RE: Submission from applicant
Ppty: 7 Centennial Ave, Lane Cove
JRPP REF#: 2012SYE008
LGA: Lane Cove Council
DA #: 233/2011

Thank you for the opportunity to make this submission in response to the Lane Cove Council ("Council") Assessment Report ("Report") for our Development Application at 7 Centennial Ave, Lane Cove.

Figure 1: shows the quarry when looking at the site from the south.

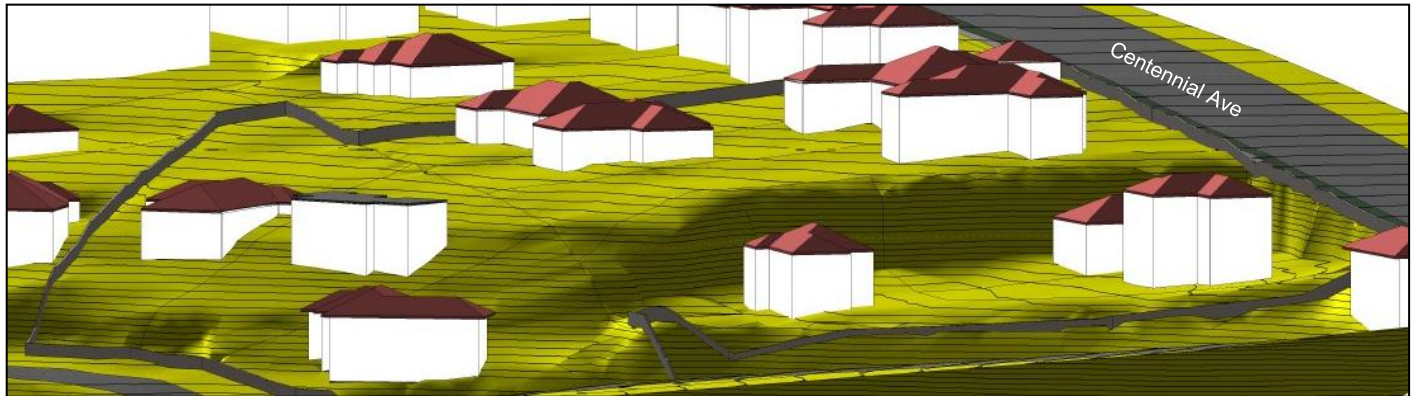
CONCLUSION 3: *The proposed development seeks an exception to the building height standard of the Lane Cove Local Environmental Plan in Block C and the variation is significant. While Blocks A and B comply with the overall building height requirement, the existing ground has been excavated and lowered to create a new ground level lower than the existing ground level to accommodate more dwellings.*

Block C of our proposal sits within the deep hole shown above. If we applied the LEP definition of the existing ground level, then the height plane would follow the ground level and the design would have reflected an awkward sheer drop in this height plane.

We did not simply guess where the natural ground levels would have been before the quarry excavation. We engaged a geomorphologist to conduct an assessment of the natural ground level. The assessment, conducted by Strategic Environmental and Engineering Consulting (SEEC), which determined a number of factors that suggest the shape and nature of landscape at the site before quarrying took place, was submitted as part of the development application.

Hyecorp has conceded that the proposed development does not comply with the height limit (only) for Block C. For this reason, as part of the application we have submitted a statement pursuant to clause 4.6 of the Lane Cove LEP requesting a contravention of the height standard in the LEP. We believe clause 4.6 in the LEP was inserted to deal with scenarios **exactly** like the quarry situation we face in this application.

Figure 4: shows the awkwardness of a design for Block C if the existing ground level was applied as the ground level. The red dotted line is what the height plan (maximum height limit) would look like if the existing ground level was taken to be the ground level.

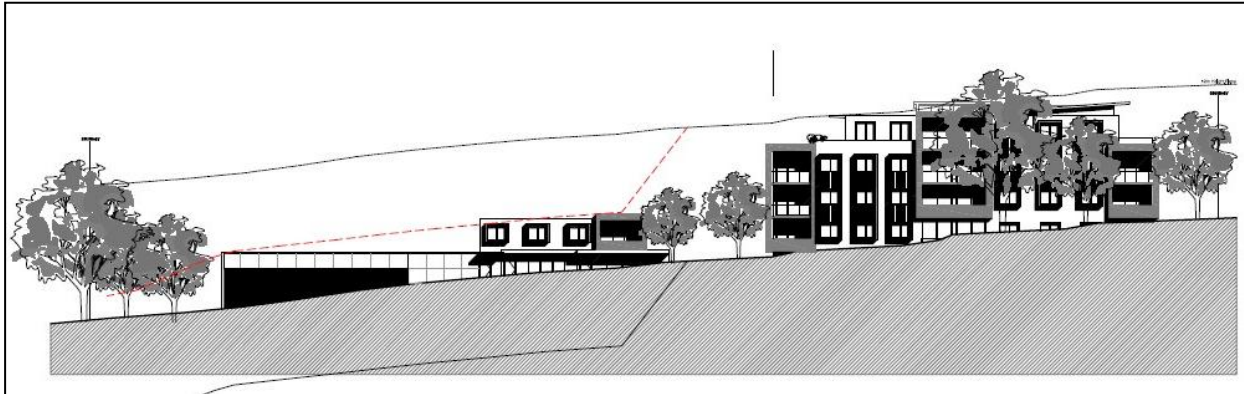
One small example of why using the natural ground level is a better planning outcome, can clearly be seen when assessing what the eastern elevation (facing Centennial Ave) would look like if we used the existing ground level as required in the LEP.

It is clear that Block C (on the left) is completely disproportionate to Block B (on the right). This is because Centennial Ave has a ground level consistent with the existing ground level 'under' Block B however, hidden behind the Street, the land underneath Block C is between 6 to 8 m below ground due to the quarrying activities.

The above Figure 4 should then be compared to the eastern elevation of our proposal:

Figure 5, which is the eastern elevation of our proposal along Centennial Ave when adopting the natural ground level, shows a design much more in keeping with the future desired character of the street and a much better planning outcome.

Fig 6: area highlighted in red shows the portion of the uppermost level of Block A that is 14-16m from Block B, not the numerically prescribed 18m

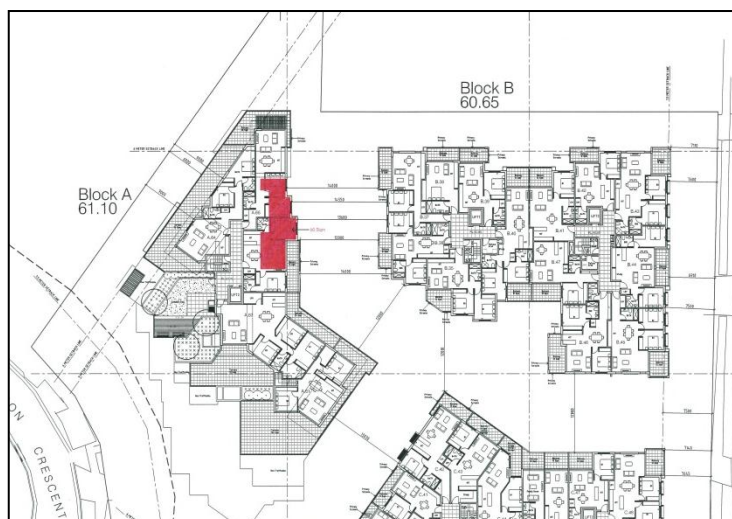
CONCLUSION 4: The proposal has not been endorsed by Council's consulting architect with regards to good design principles of the SEPP 65. Provision of privacy screens would not satisfy the prescriptive measure of separation between buildings.

The only issue that can be discussed is the provision of privacy screens on the upper most floor of Block A on the eastern elevation (facing Block B). On this elevation, following Council's advice, Hyecorp has provided privacy screens to ensure visual and acoustic amenity is provided and therefore satisfy the objectives of the building separation requirement.

Hyecorp would like to advise the JRPP that if Panel members are of the opinion that this is not acceptable, Hyecorp will look at redesigning this small section of Block A to provide this separation. However we have not done so as it was agreed between Hyecorp and Council that the area in question is so minor that increased setbacks on the upper level of Block A to provide numerical compliance would impact the amenity of this upper level of Block A¹.

The image above shows the minor area in question. As you can see the area of the uppermost level of Block A (shaded in red) is very minor. This area is 14-16m from Block B.
